ADDENDUM NO. 3
HWEA CONTRACT # 133-2019-01
HAMMOND-WOOD WASTEWATER TREATMENT PLANT EXPANSION
HOPKINSVILLE WATER ENVIRONMENT AUTHORITY
HOPKINSVILLE, KENTUCKY
WAUFORD PROJECT NO. 1983

Date of Addendum: Friday, January 10, 2020
Mandatory Pre-Bid Meeting: Tuesday, January 21, 2020, 9:00 a.m. Central Time
Bid Opening: Thursday, February 6, 2020, 2:00 p.m. Central Time

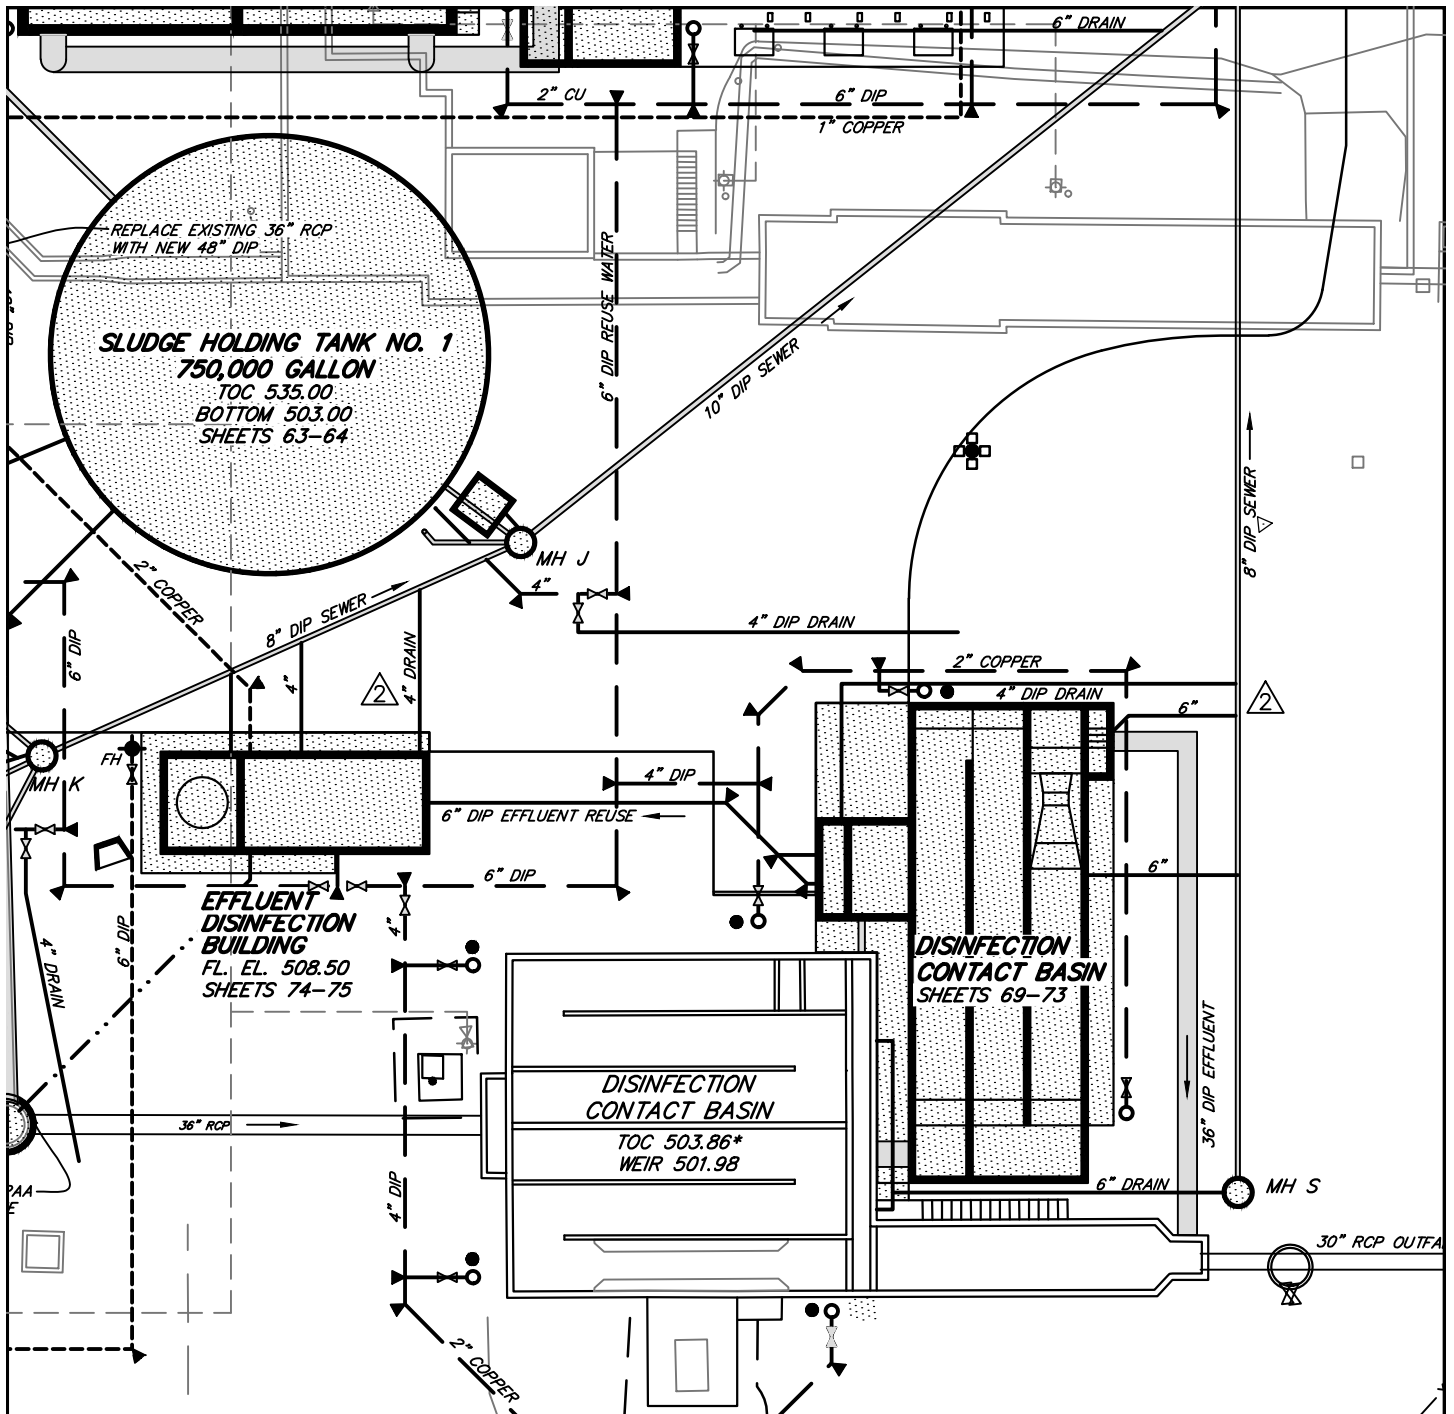
6. Plans, Sheets 3, 7, and 9:

Modify the existing Oxidation Ditch No. 1 weir elevation as follows:

“WEIR 511.45”

7. Plans, Sheets 7, 23, 24, 27, 39, 47, 56, 59, 60, 69, 73, 77, 79, 81, and 82:

Modify these sheets as shown on the attached 8 ½” X 11” sheets.

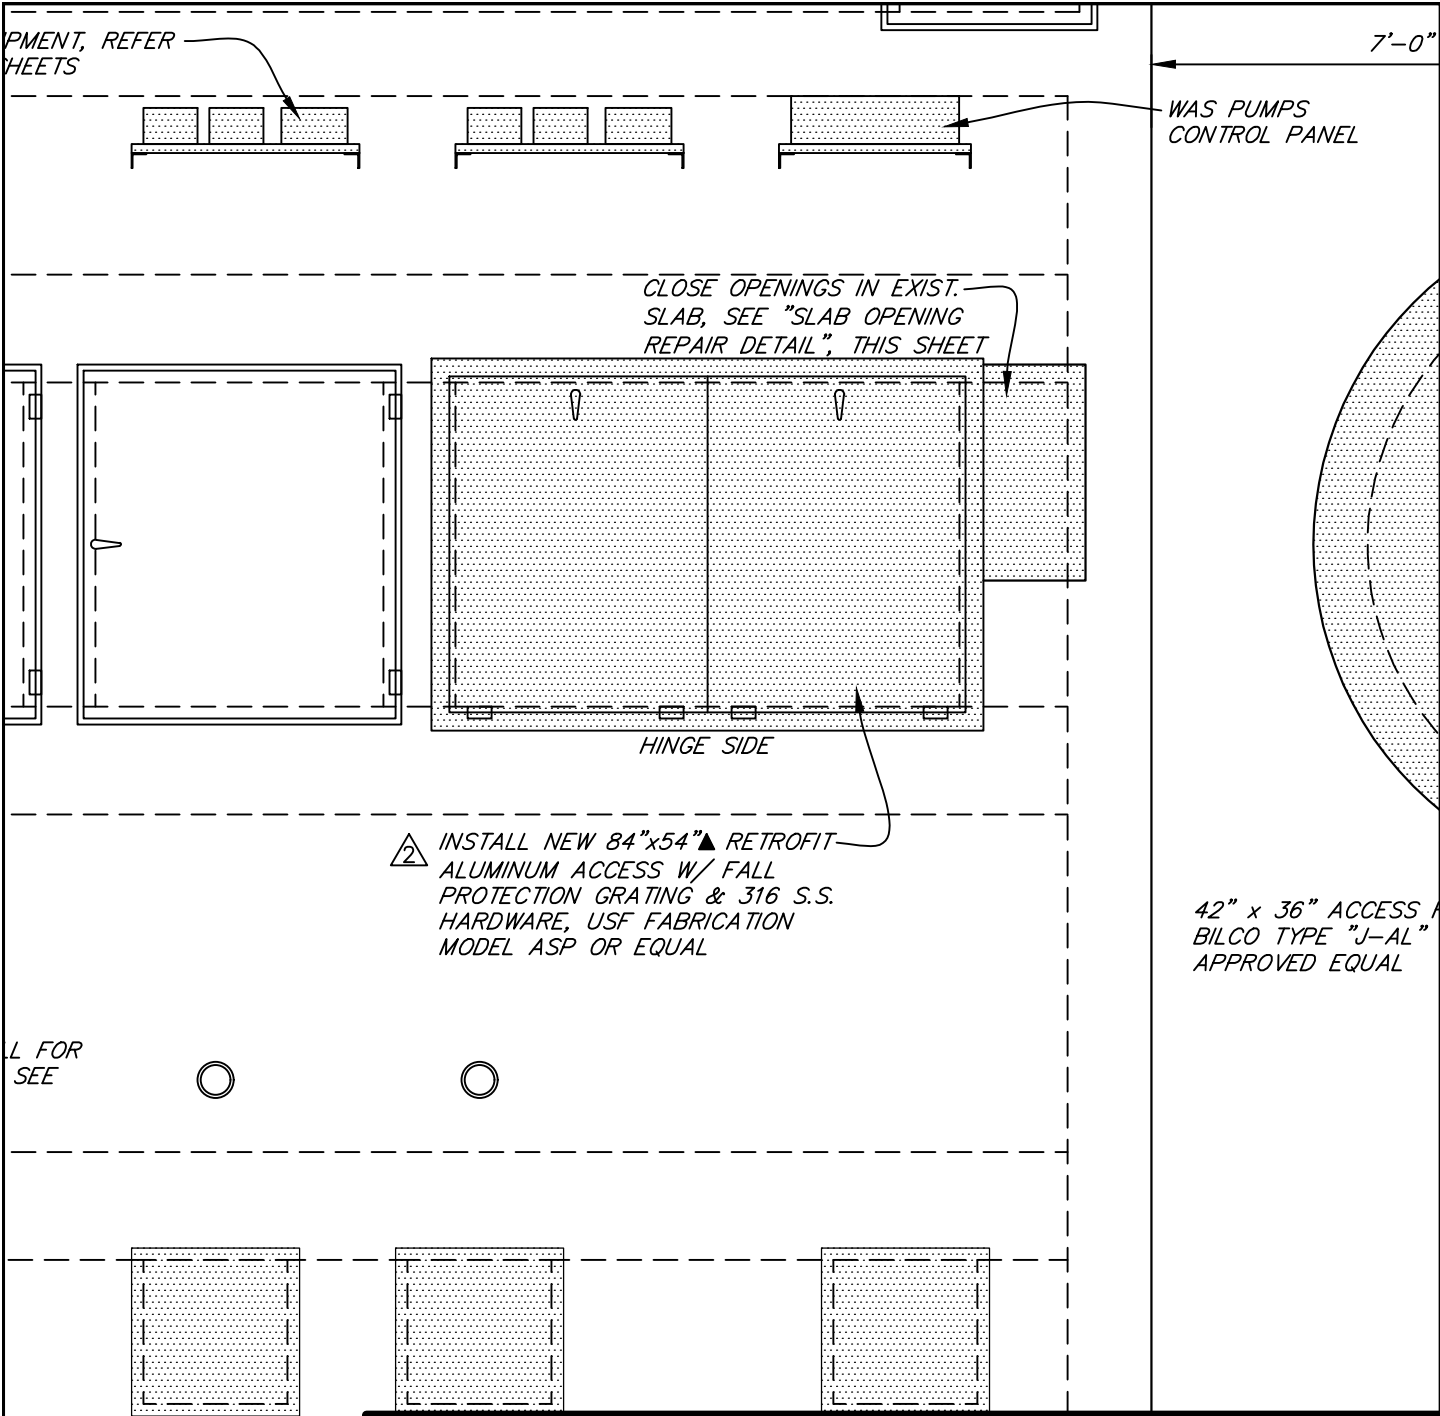
▲
 INSTALL NEW 84"x54"▲ RETROFIT
 ALUMINUM ACCESS W/ FALL
 PROTECTION GRATING & 316 S.S.
 HARDWARE, USF FABRICATION
 MODEL ASP OR EQUAL

EFFLUENT BOX PLAN

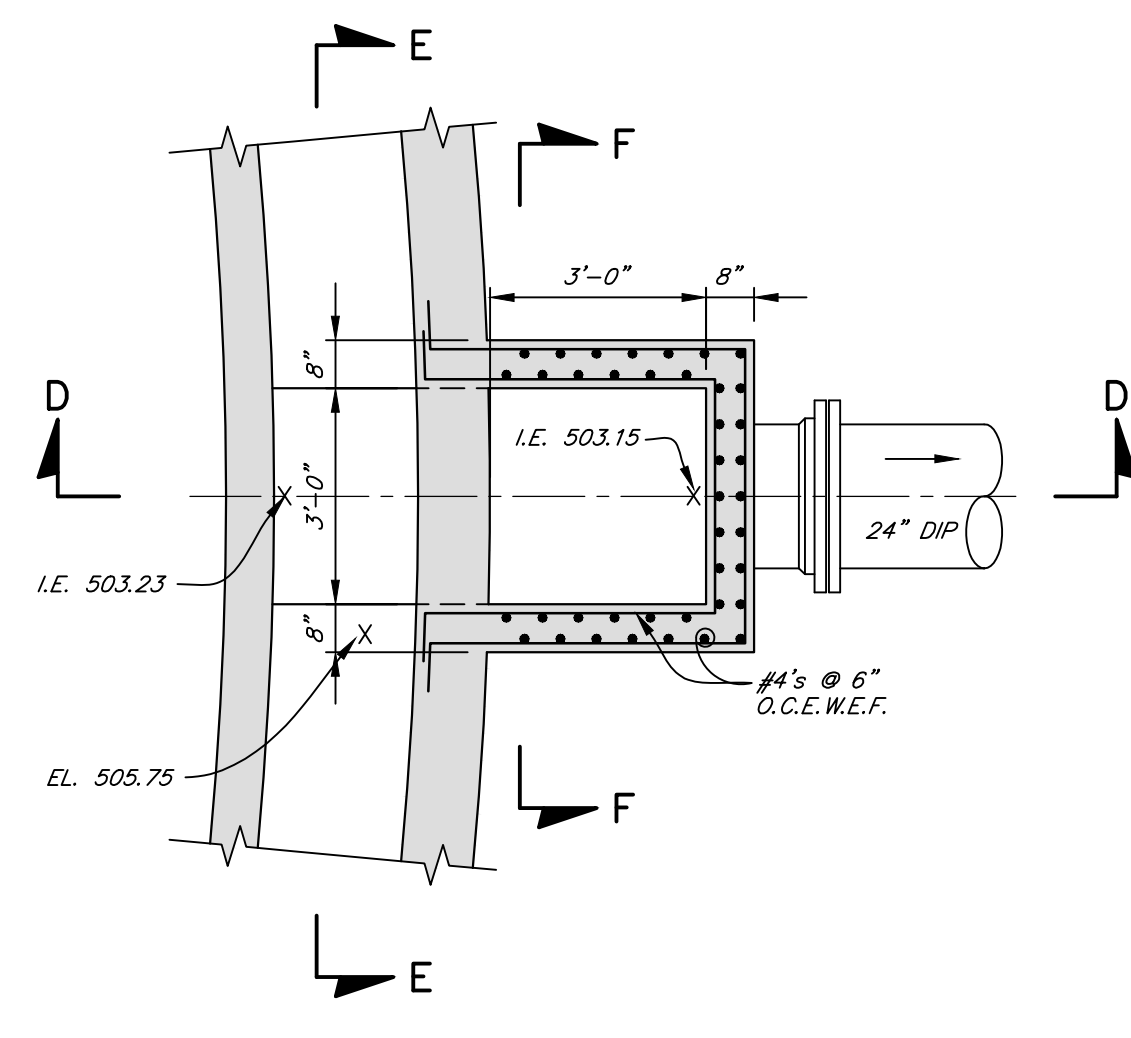
10. Plans, Sheets 40 and 43, Proposed Oxidation Ditch No. 3, 36” Dip Effluent to Mixed Liquor Distribution Structure:

Modify the I.E. at the effluent box as follows:

“I.E. 498.33”
